**1 EVANSTON 'D'**  
**FRONT ELEVATION**  
1/4" = 1'-0"

**GENTRY DESIGN STUDIO**  
128 SOUTH CHESTNUT • OLATHE, KS 66061  
PHONE - 913-393-0175

**ABP FUNDING, LLC**  
9101 W. 110TH ST., #200, • 913-208-2288  
OVERLAND PARK, KANSAS 66201

**EVANSTON 'C'**  
**1 FRONT ELEVATION**  
1/4" = 1'-0"

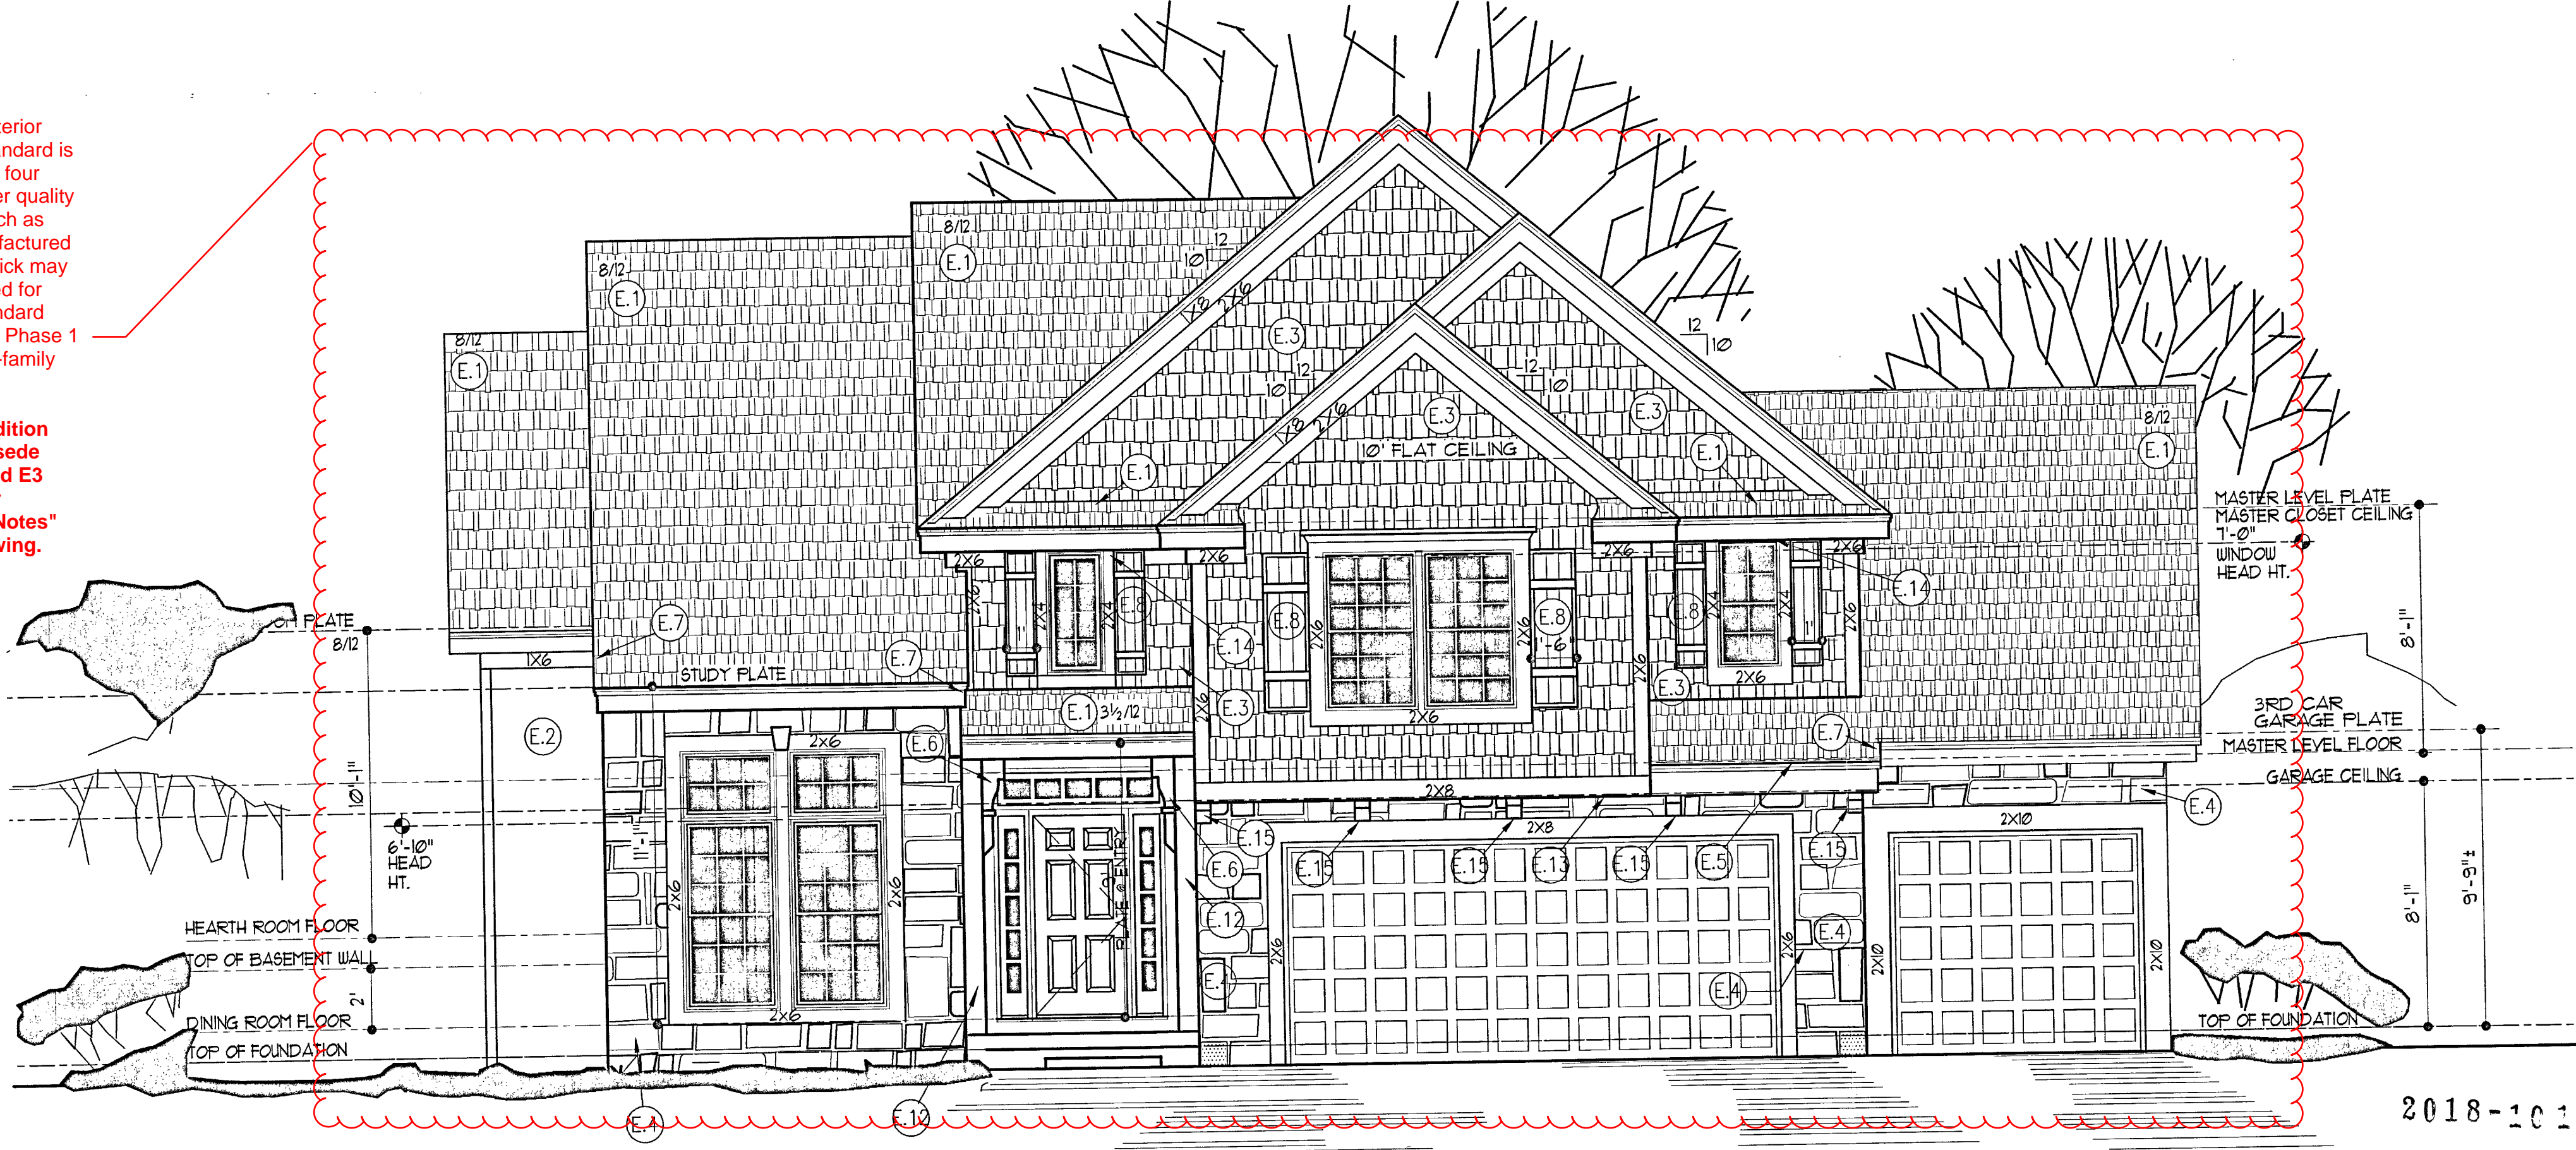
\*\*\*This condition shall supersede note E2 listed under "Elevation Notes" on this drawing.

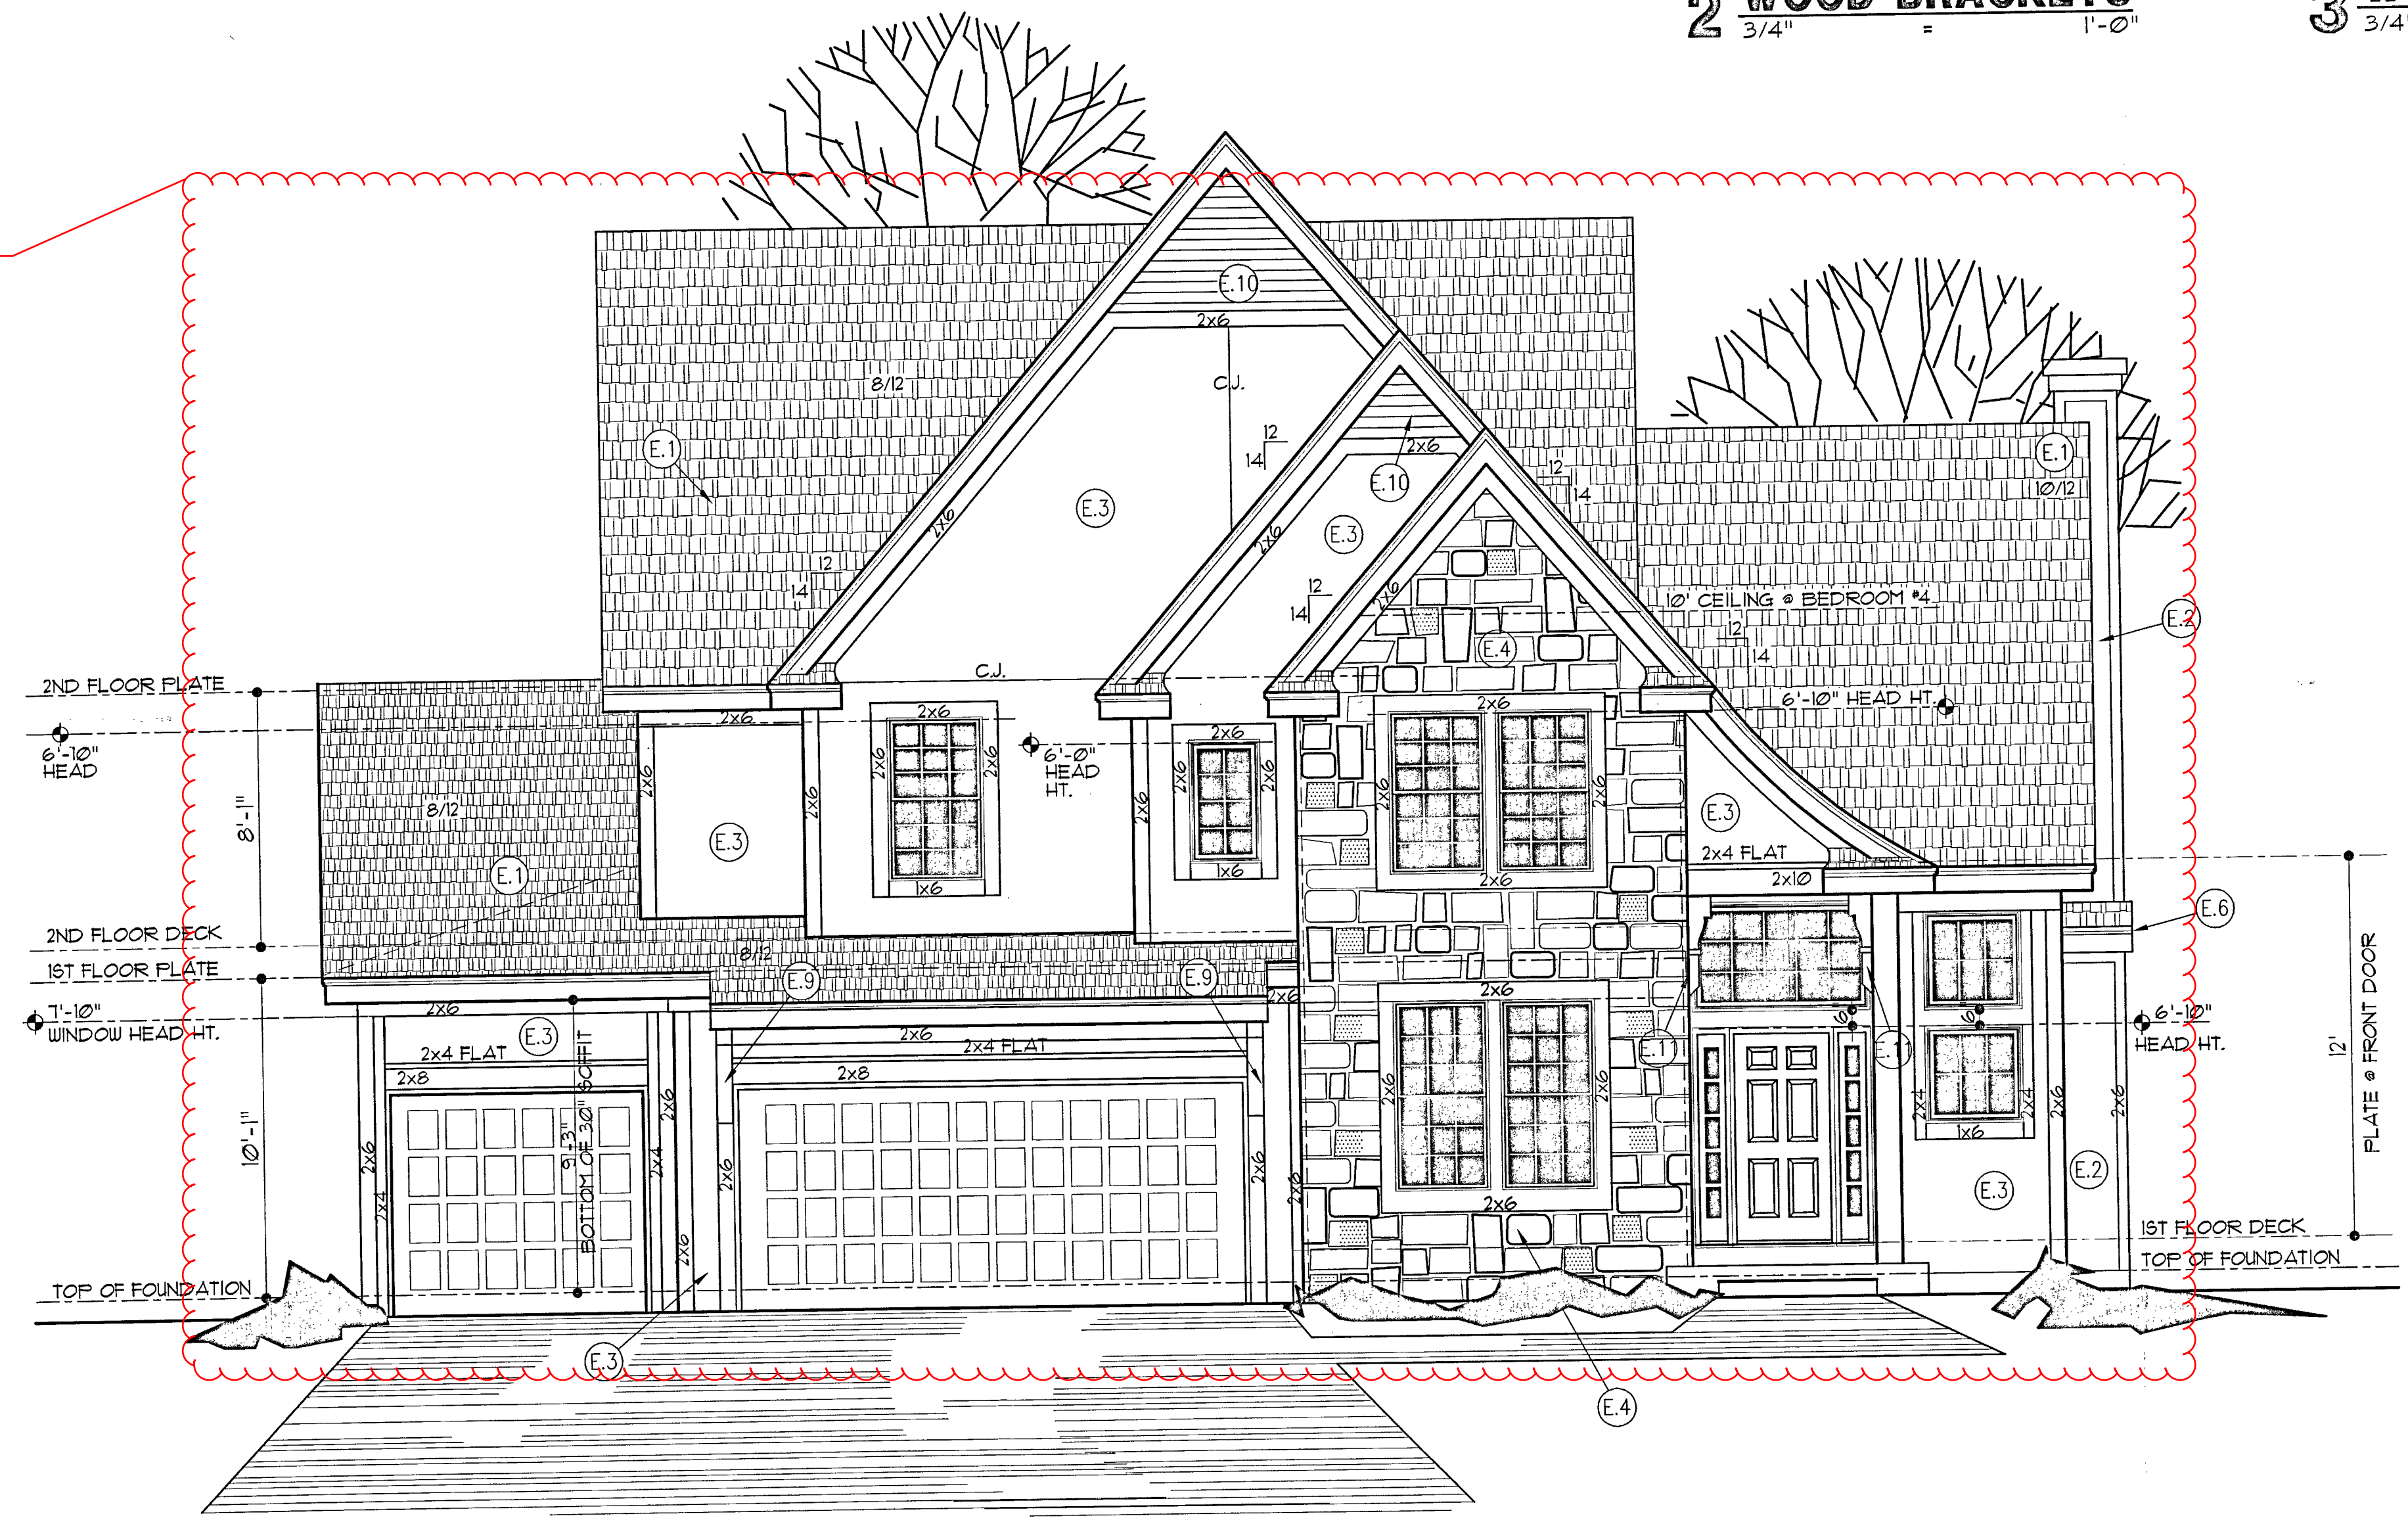
Minimum exterior materials standard is stucco on all four sides. Higher quality materials such as stone, manufactured stone and brick may be substituted for stucco. Standard applies to all Phase 1 and 2 single-family homes.\*\*\*  
\*\*\*This condition shall supersede note E2 listed under "Elevation Notes" on this drawing.
